DECLARATION OF SIMILARITY

We, Zhuhai Suny Technology Co., Ltd., hereby state that the differences between the products: ESL (Electronic Shelf Labels), models ET0266-82 and ET0266-5B are as described below. The relevant test results are documented in the report issued by Bay Area Compliance Laboratory Co., Ltd. (New Taipei City Laboratory), Project No.: RXZ260319063.

FCC ID: 2BU9I-ET0266-82

- 1 model name
- 2 Appearance color

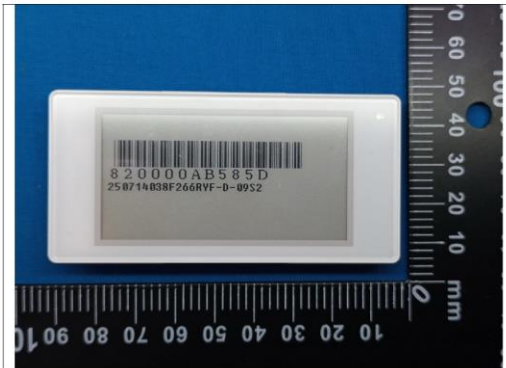
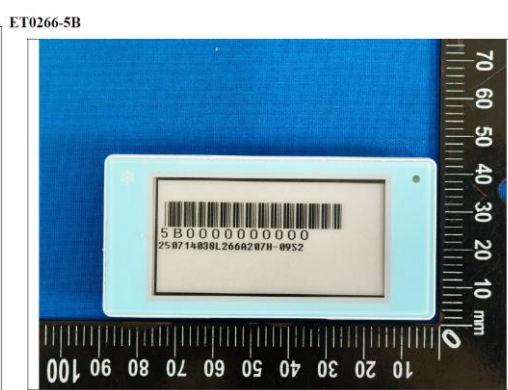
shell color(white)
ET0266-82

shell color(blue)
ET0266-5B

3 PCB board routing

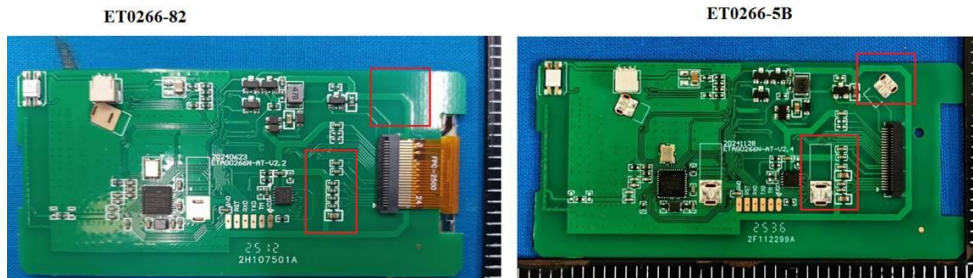
The differences in the welding holes of battery spring pieces and the size of surface mount capacitor packages do not affect the RF part

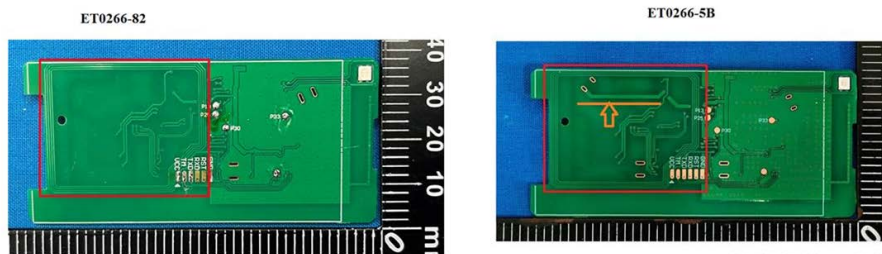
The following different traces only affect the power supply of the battery and do not affect the RF part
